DOCUMENT CHANGE REQUEST

DCR number 334	Changes required for: General	Originator: S Jeffery
Date: 2007/04/17	Date sent: 2007/04/17	Organisation: ESA/ESTEC
Status: IMPLEMENTED

Title:	Matched Dual Transistors NPN, based on types 2N2919/2N2920 and 2N2920A		
Number:	5207/002	Issue:	1

1.6.1 Metal Can Package (TO-77) - 6 lead

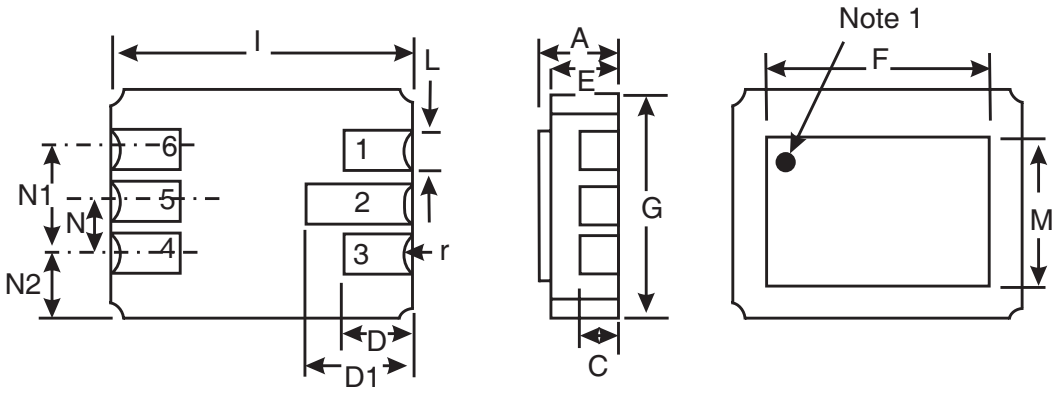
7. Para. 4.3.2 Weight requirements moved to Component Type Variants table.
8. Figure 2 re-named "Physical Dimensions and Terminal Identification"; Figure 2(a) amended to reflect the TO-77 package currently supplied; Figure 2(b) amended to reflect the CCP package currently supplied.
